**MONTGOMERY COUNTY HISTORIC PRESERVATION COMMISSION**  
**STAFF REPORT**

<b>Address:</b>	5 Montgomery Ave., Takoma Park	<b>Meeting Date:</b>	6/26/2024
<b>Resource:</b>	Contributing Resource <b>Takoma Park Historic District</b>	<b>Report Date:</b>	6/18/2024
<b>Applicant:</b>	Margo Ricks, Agent	<b>Public Notice:</b>	6/12/2024
<b>Review:</b>	HAWP	<b>Tax Credit:</b>	no
<b>Case Number:</b>	1068720	<b>Staff:</b>	Dan Bruechert
<b>Proposal:</b>	Solar Panel Installation

**RECOMMENDATION**

Staff recommends that the Historic Preservation Commission **approve** the HAWP application.

Figure 2: The proposed solar panel layout. Five panels are on the street-facing roof slope.

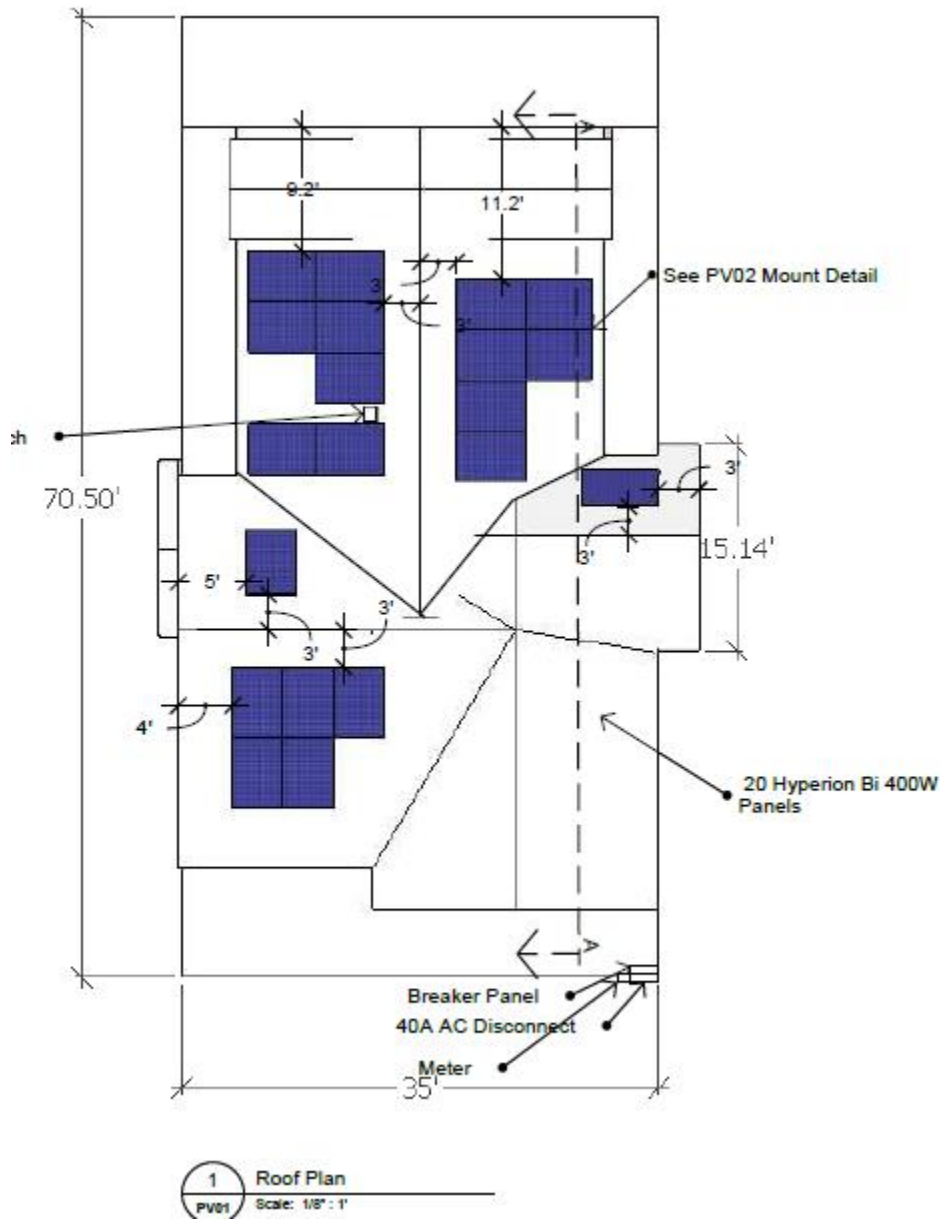
The applicant proposes to install a majority (13 of 20) of the solar panels on the recently completed rear addition.

Staff finds these panels are located in one of the preferred locations identified in the HPC's adopted solar panel policy – non-historic rear additions – and that the panels will not be highly visible from the public right-of-way. Staff additionally finds that the *Design Guidelines* state alterations not visible from the right-of-way should be allowed as a matter of course. While the adopted [Solar Panel Illustrated Design Guidelines](#) show the HPC's preference for arranging panels in an organized configuration to avoid a disjointed opinion, Staff finds the limited visibility of these panels will not have a significant impact on the house's visual characteristics and will not impact the character of the district.

Staff finds the 13 (thirteen) solar panels on the rear addition will not have a significant impact on the character of the house or surrounding district and recommends the HPC approve them under 24A-8(b)(2) and (d); the *Design Guidelines*; Standards 2, 9, and 10; and the HPC's adopted solar policy.

### **Rear Roof Slopes**

The applicant proposes to install two solar panels on rear-facing roof slopes. One panel will be installed on the south-facing roof slope on the east-facing gable and one on the west-facing gable. These two panels are in one of the preferred locations (on the rear of the property) in the HPC's adopted solar policy.

Staff finds that neither of these panels will be visible from the public right-of-way and that their installation will not impact the roof profile. Staff additionally finds that the *Design Guidelines* state alterations not visible from the right-of-way should be allowed as a matter of course. As with the panels on the non-historic addition, Staff does not find that the arrangement of the panels will detract from the character of the house or surrounding district because they will not be at all visible from the public right-of-way.

Staff finds the two solar panels on the rear-facing gables will not have a significant impact on the character of the house or surrounding district and recommends the HPC approve them under 24A-8(b)(2) and (d); the *Design Guidelines*; Standards 2, 9, and 10; and the HPC's adopted solar policy.

### **Front-Facing Roof Slope**

On the left (east) side of the front-facing roof slope, the applicant proposes to install 5 (five) solar panels. These panels will be highly visible from the public right-of-way. The street-facing roof slope is not a preferred location for solar panels for Contributing and Outstanding Resources.

When solar panels are proposed for the front roof slope, the applicant needs to first, demonstrate that none of the preferred locations are feasible. In this instance, the applicant proposes to install panels in two of the preferred locations (a non-historic addition and rear roof slope); and the other two preferred locations (an accessory structure and ground-mounted array) are not feasible due to the size of the lot and the small size of the existing shed. Second, the roof needs to be found to be neither architecturally significant nor a material that will be irreparably damaged by the solar installation. Staff finds a complex roof form is typical of Queen Anne architecture, however, Staff also finds that the character of the roof will not be significantly harmed by installing the solar panels. Additionally, the recently installed architectural, asphalt shingle roof will not be irreparably damaged by installing these roof-mounted solar panels. Finally, the applicant demonstrated that the estimated solar panel will likely not exceed the house's electricity needs.

*Figure 3: The subject property (shown with a star) and the only Outstanding Resource at 10 Pine Ave. (shown with a +).*

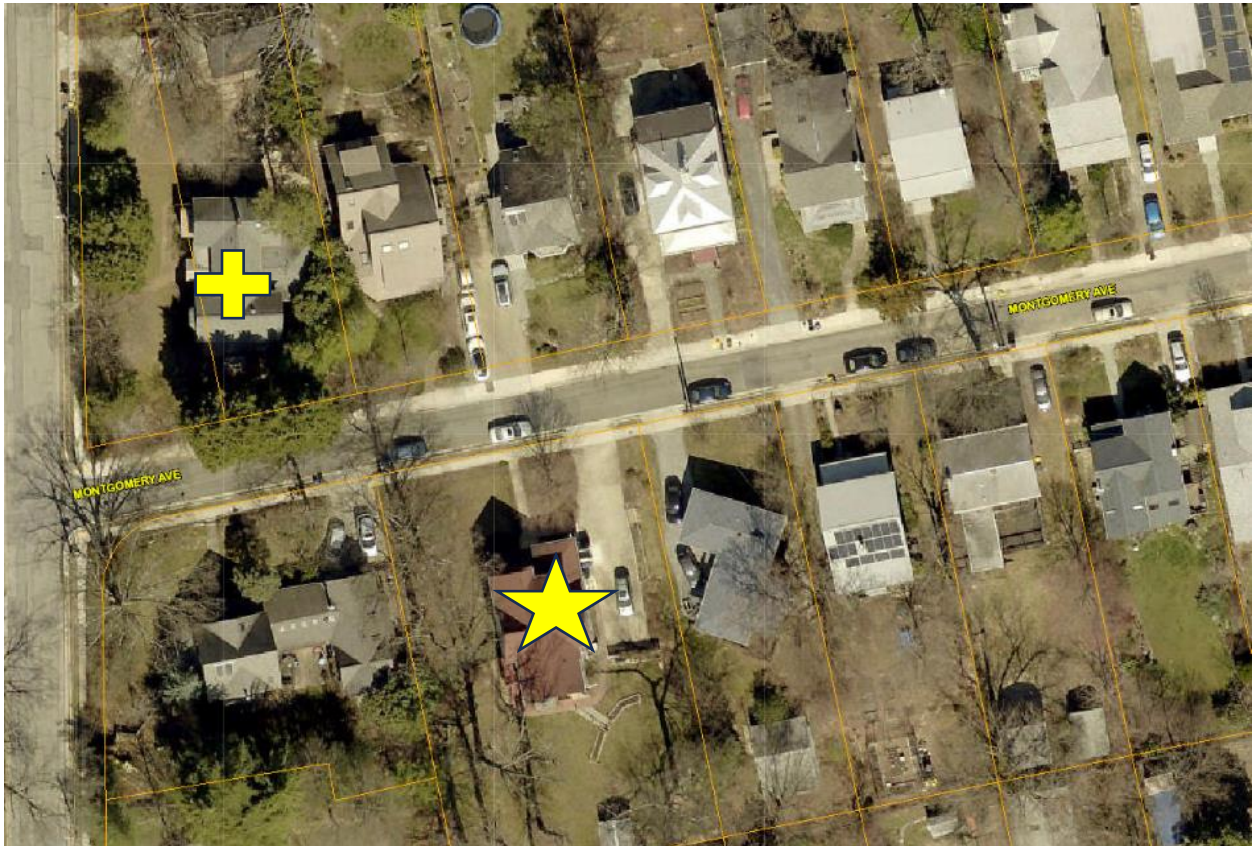
In the immediate area surrounding the subject property, there is one Outstanding Resource, at 10 Pine

Ave. The remaining houses are Non-Contributing or Contributing. Staff finds installing solar panels on the front elevation will not impact the viewshed of any significant resources.

Staff finds the proposed front-facing solar panels will not seriously detract from the character of the house and surrounding district; and can be removed without damaging historic fabric. Staff finds the 5 (five) solar panels on the front-facing roof slope will not have a significant impact on the character of the house or surrounding district and recommends the HPC approve them under 24A-8(b)(2) and (d); the *Design Guidelines*; Standards 2, 9, and 10; and the HPC's adopted solar policy.
